stuart buzzard point | washington, dc

april 24th, 2026

proposed phase 1: 1st floor plan

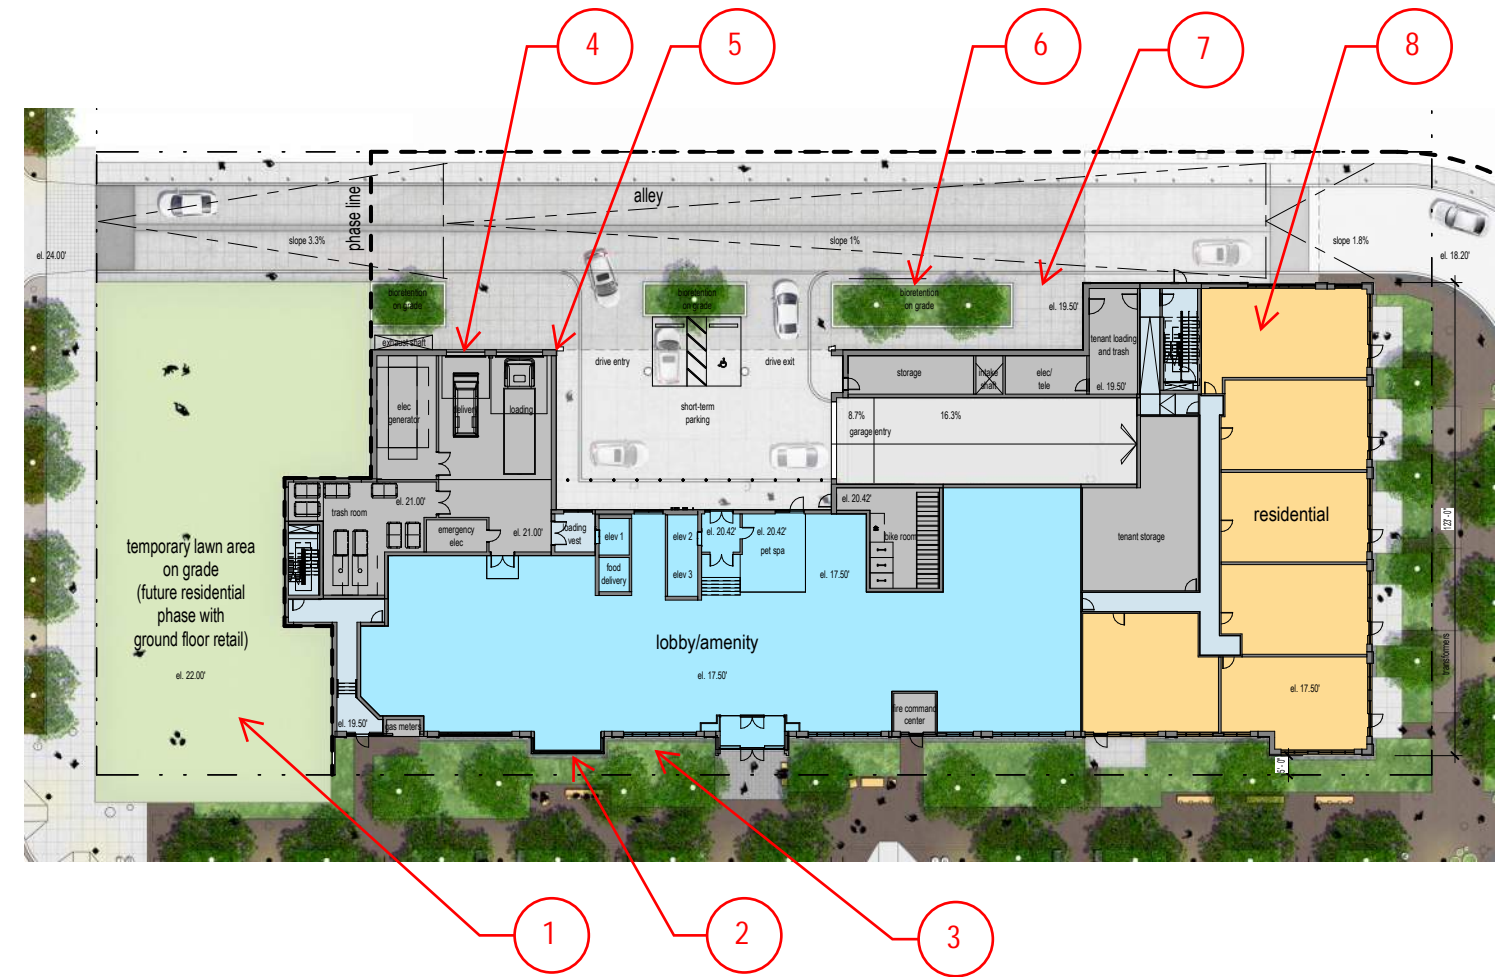
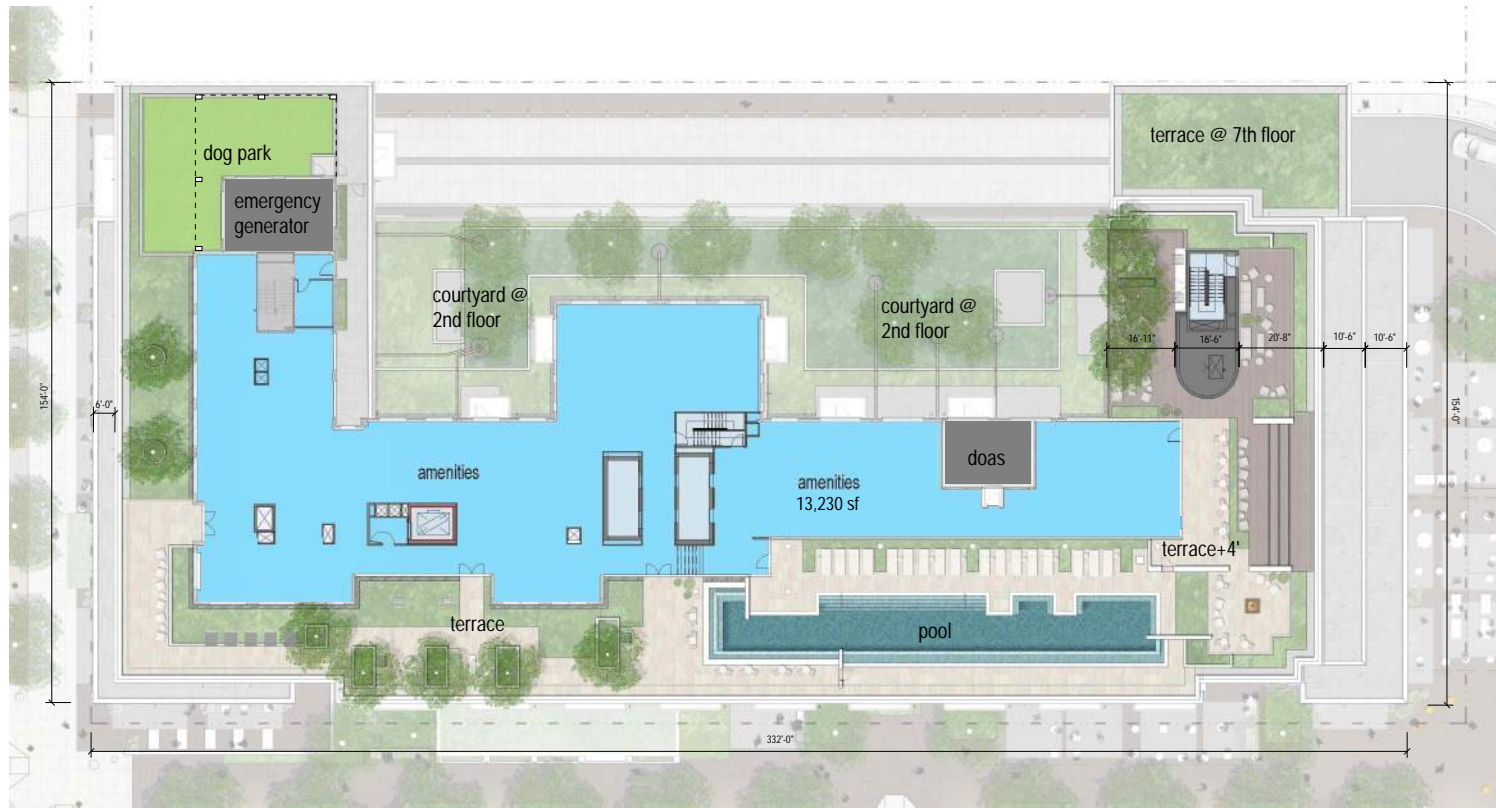
1. for feasibility purposes, re-phasing of building development removes west wing as part of phase 1 and replaces the footprint of the west wing with temporary lawn space until the future residential phase is constructed with ground floor retail. phase 1 unit count is reduced from 452 to approximately 335.

2. bay window has shifted east in coordination with amenity space inside.
3. canopy and amenity indoor/outdoor space have been removed and replaced with green space.

4. loading, delivery, and electrical generator have been relocated in coordination with new phasing.
5. exterior facade at dropoff has been pushed back to provide light and breathing room to the alley, as well as daylight and visibility to the dropoff.

6. bioretention has been added on grade along the alley, providing more greenery to soften alley.
7. additional short-term parking/loading space has been located near east wing back of house.

8. residential loft units with individual direct street entrance added to promote better streetscape engagement and ensure activation in light of ongoing retail market challenges.

proposed phase 1: penthouse floor plan

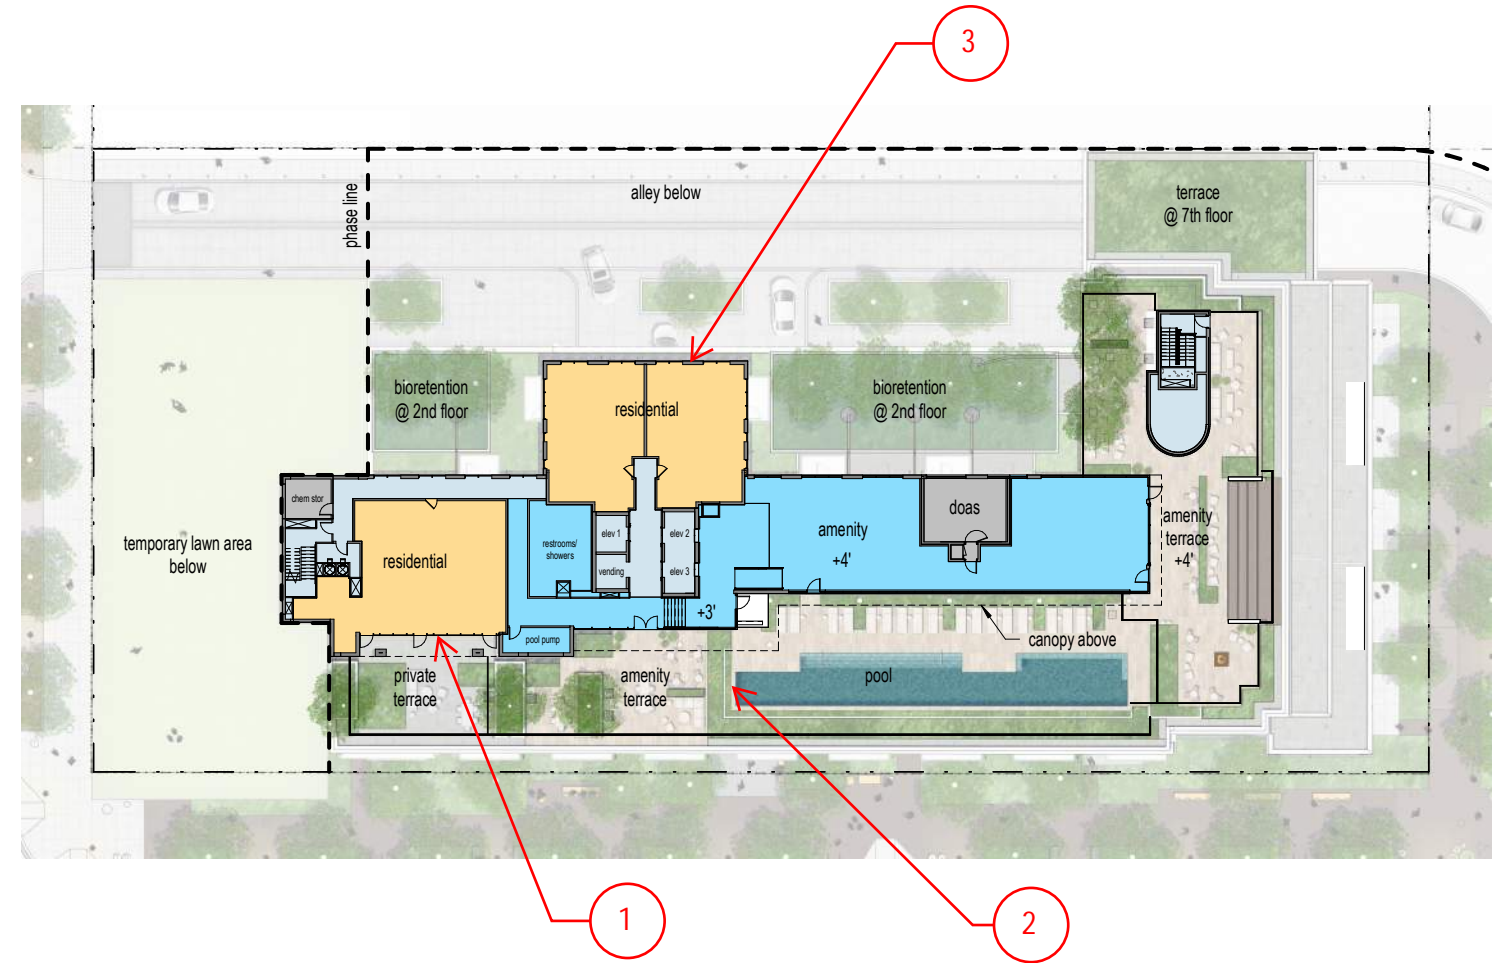
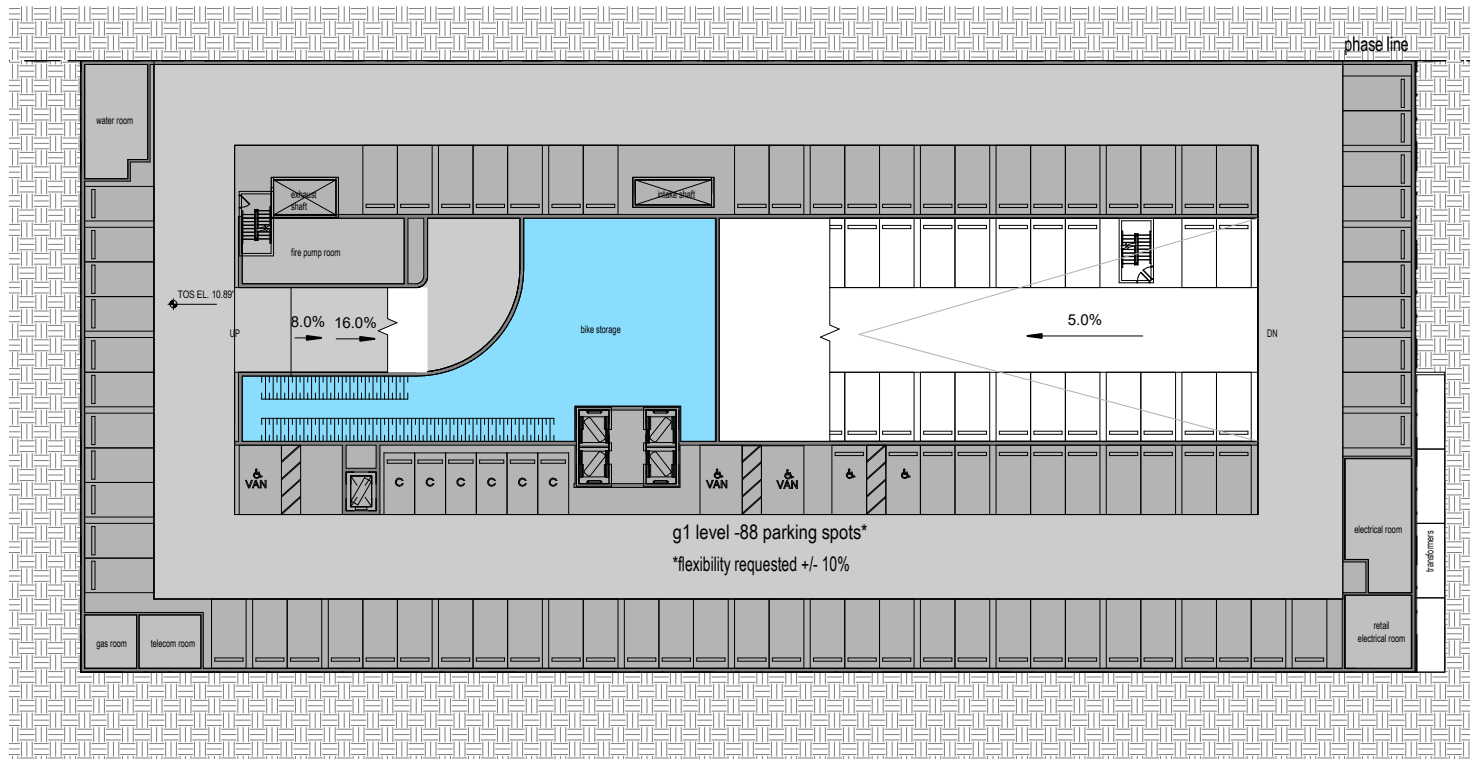
1. unit and private terrace have been added at west end of new phase 1 building in place of amenities, which were relocated to the 1st floor to provide street activation.
2. pool deck has been shortened and shifted to align with penthouse building face and entrance to pool deck, giving more space to the year-round amenity terrace adjacent to the elevators.
3. units have been added north of the elevators in place of amenities, which were relocated to the 1st floor.

proposed phase 1: g1 level plan

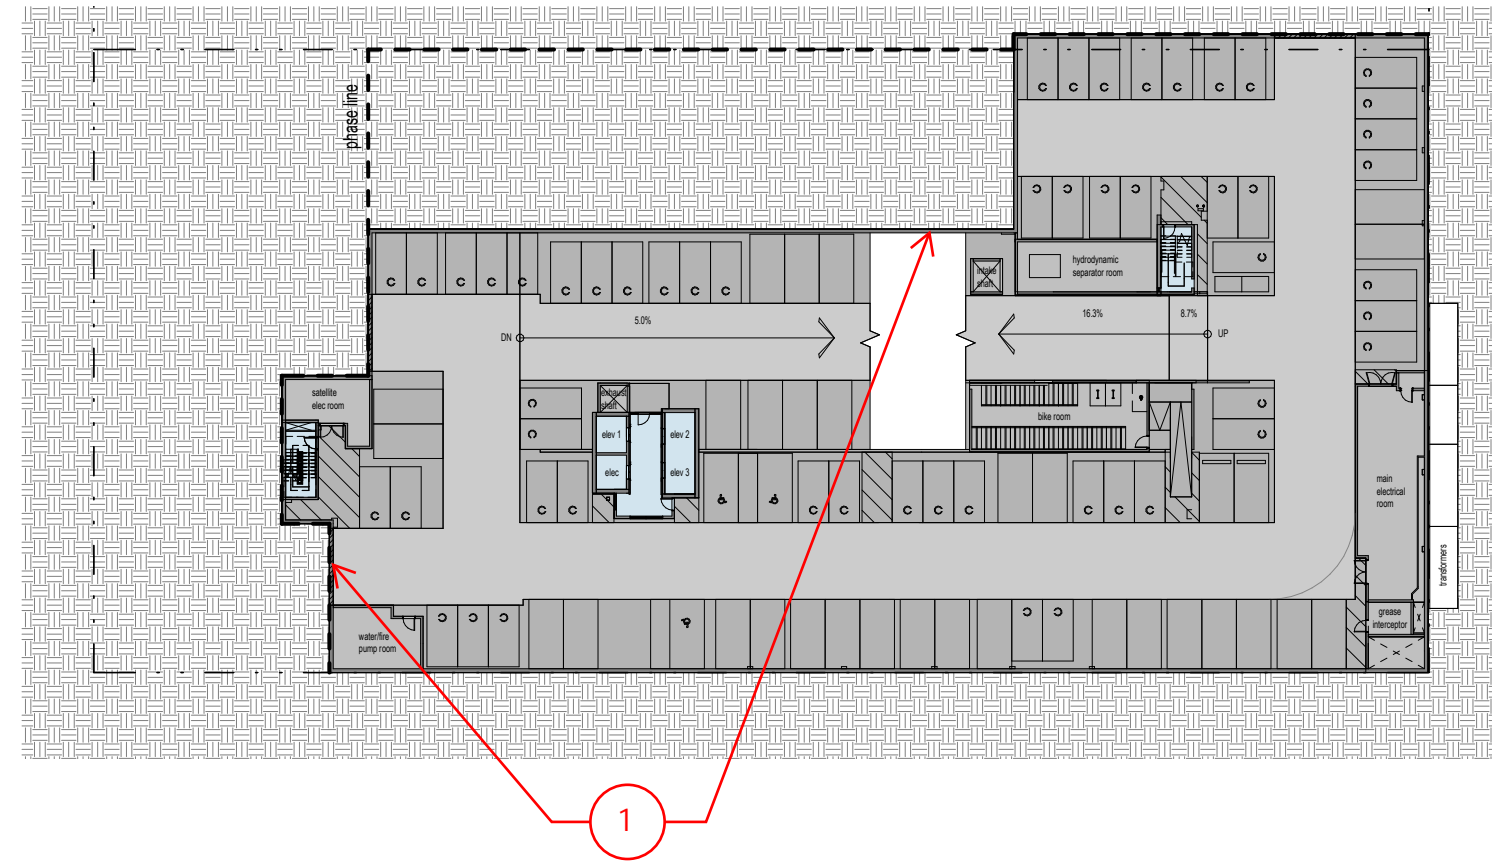
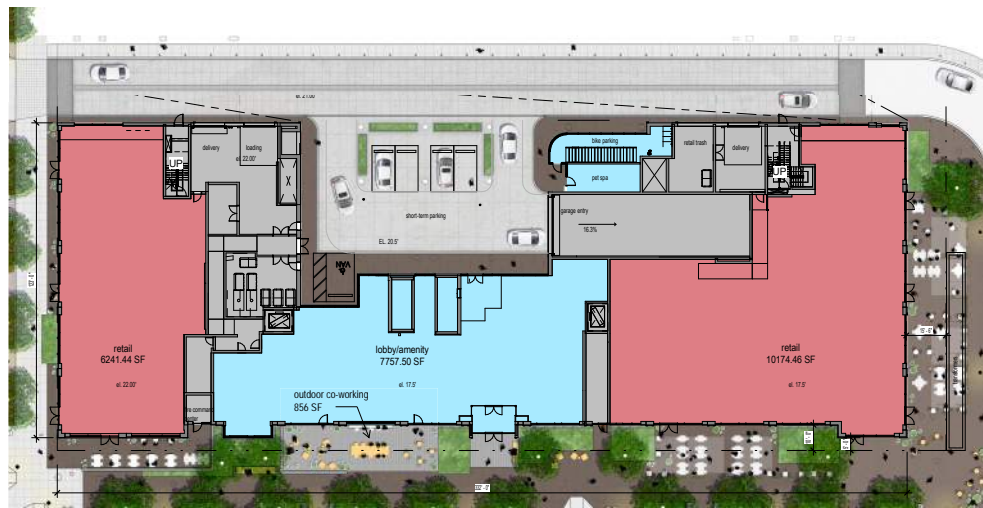
1. garage footprint has been reduced in coordination with new phase line of building. total number of parking spaces has been reduced from 264 to 196 in response to reduced number of units and removal of retail as part of phase 1.

proposed phase 1: north elevation

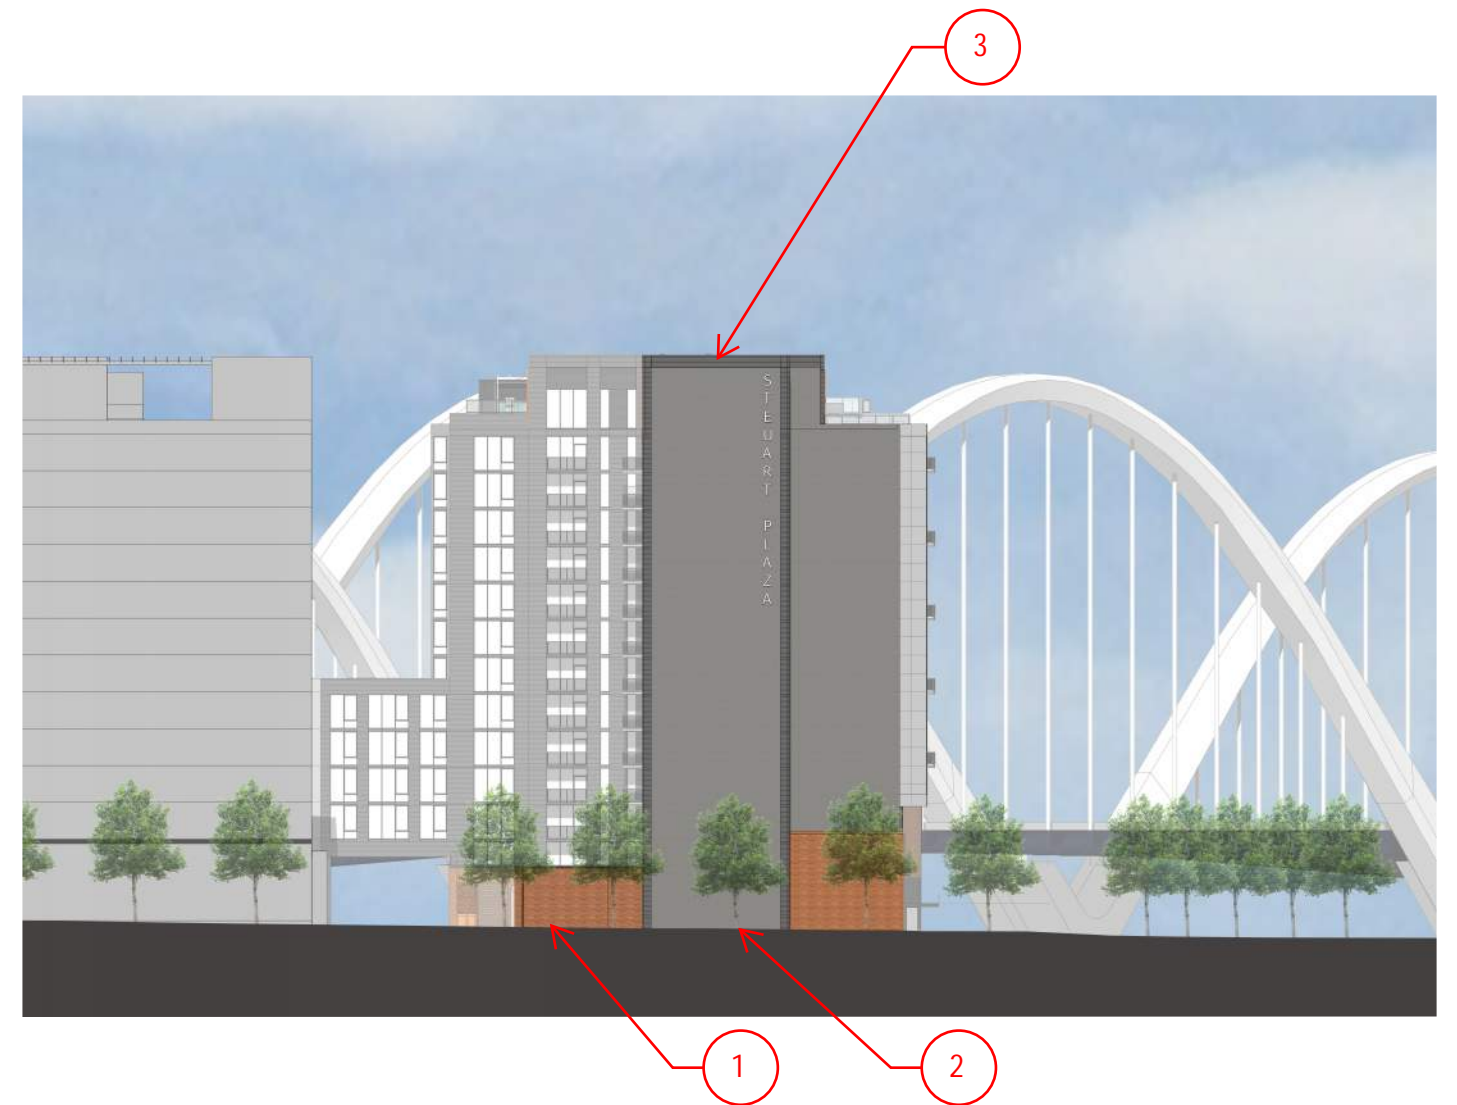
1. additional short-term parking/loading space has been located near east wing back of house.
2. bioretention has been added on grade along the alley, providing more greenery to soften the alley.
3. exterior facade at dropoff has been pushed back to give some light and breathing room to the alley, as well as daylight and visibility to the dropoff.
4. loading, delivery, and electrical generator have been relocated in coordination with new phasing.
5. rephasing of building development removes west wing as part of phase 1 and replaces the footprint of the west wing with temporary lawn space until the future residential phase is constructed with ground floor retail.
6. west end of north facade is similar to previously approved facades where future phase connections will be made with metal panel trim surrounding EIFS on CMU with space for building signage.

proposed phase 1: east elevation

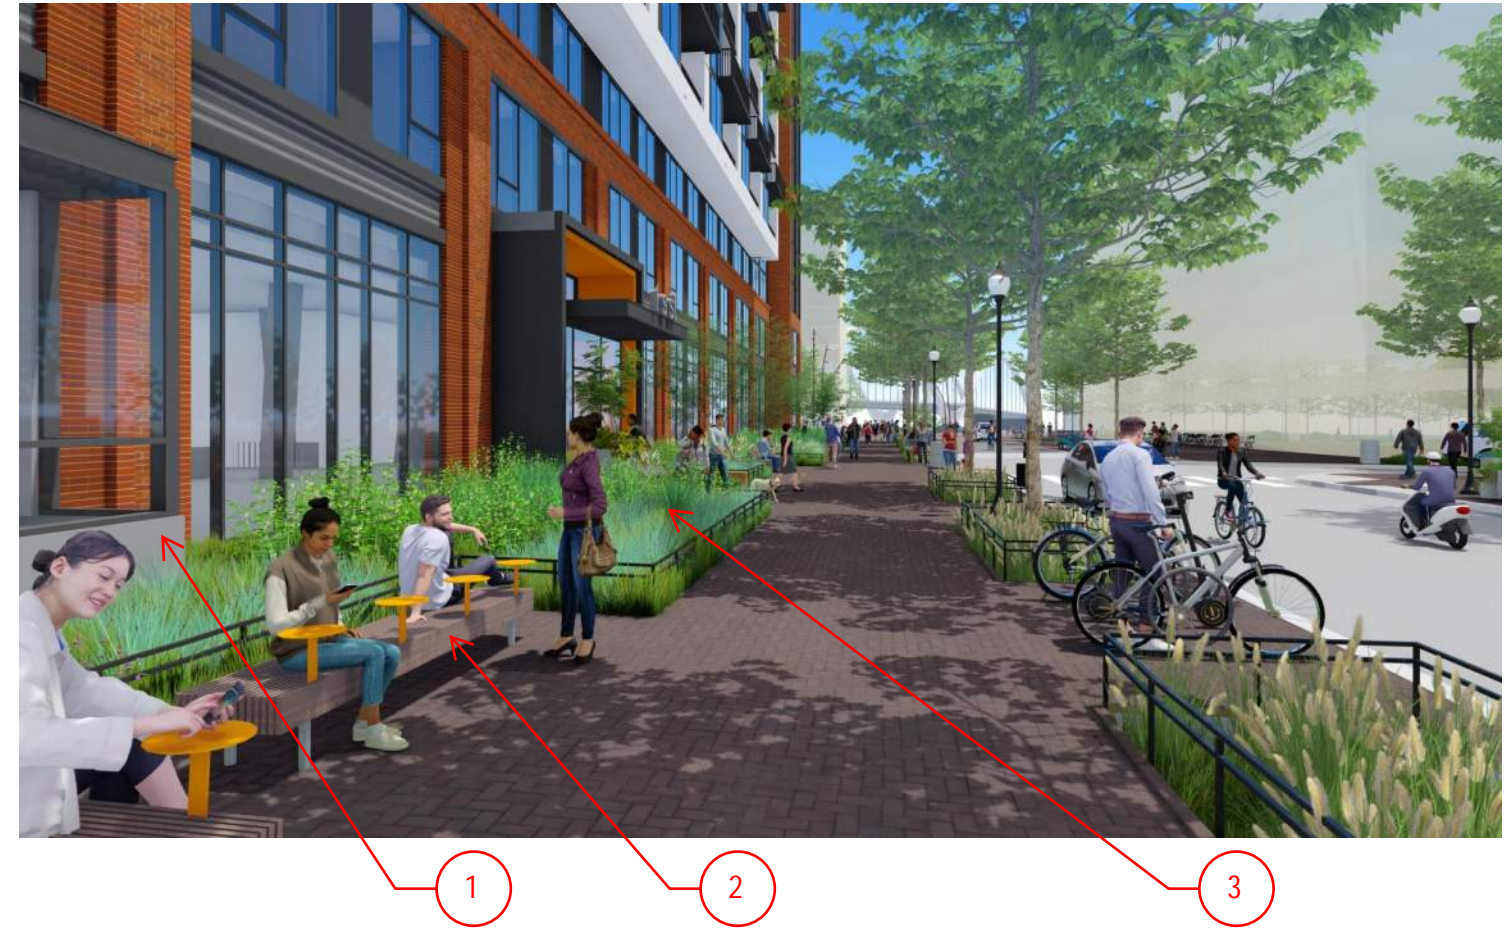
1. residential loft units with individual direct street entrance added to promote better streetscape engagement and ensure activation in light of ongoing retail market challenges.
2. unit entry marquee provided with lighting
3. clerestory glazing provided to allow additional daylighting of taller lofted unit
4. unit patios with modest privacy walls
